# Access Compliance Report

## Public Rights-of-Way

Intersection ID: 51181	Main Street: FIRCREST_DR	Cross Street: WHIPPET_RIDGE_CT	Location: NE
ADA ID: 4EED3DE4135F	Ramp Type: PerpDiag	Initial Pass/Fail: Fail	Overall Compliance: No
Severity Score: 12.5			
Codes/Mitigation Info/Possible Solution		Field Measurements/Component Compliance

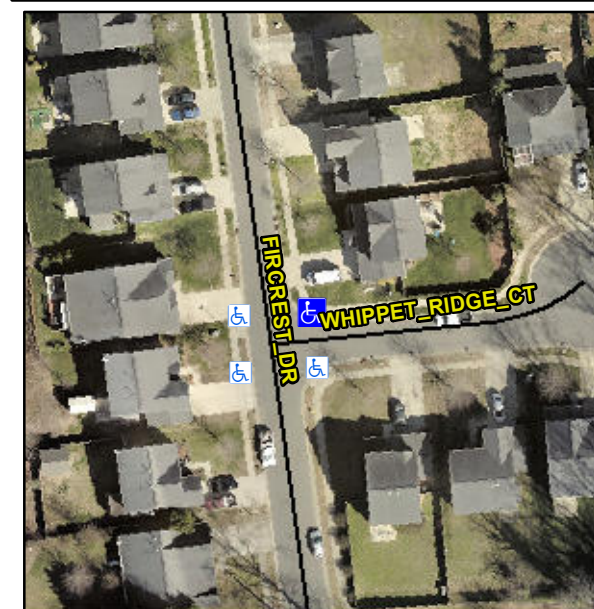
**Remove & Replace Curb Ramp With Two New Directional Ramps or Equivalent.**

**R304.5.3**

Compliance	Description	Data	Compliance	Description	Data
N/A	Ramp Length (in)	48.0	Yes	Ramp Slope (%)	6.8
Yes	Ramp Width (in)	48.0	No	Ramp XSlope (%)	6.4
N/A	Flare Type LT	N/A	N/A	Flare Type RT	N/A
N/A	Flare Slope LT (%)	N/A	N/A	Flare Slope RT (%)	N/A
N/A	Flare Traversable LT?	N/A	N/A	Flare Traversable RT?	N/A
N/A	Landing Length (in)	N/A	N/A	DWS Provided?	N/A
N/A	Landing Width (in)	N/A	N/A	DWS Contrast?	N/A
N/A	Landing Slope (%)	N/A	N/A	DWS Length (in)	N/A
N/A	Landing X Slope (%)	N/A	N/A	DWS Full Width?	N/A
N/A	Landing Curb? (Y/N)	N/A	N/A	DWS Offset (in)	N/A
N/A	Shared Landing?	N/A			
N/A	Gutter Ponding?	N/A	N/A	Gutter Slope (%)	N/A
N/A	Gutter Lip Ht (in)	N/A	N/A	Gutter X Slope (%)	N/A
N/A	Painted X Walk1?	No	N/A	Painted X Walk2?	No
	X Walk 1 Direction	To W		X Walk 2 Direction	To S
N/A	X Walk 1 Width (in)	N/A	N/A	X Walk 2 Width (in)	N/A
	X Walk 1 Slope (%)	0.3		X Walk 2 Slope (%)	5.0
	X Walk 1 X Slope (%)	5.0		X Walk 2 X Slope (%)	2.2
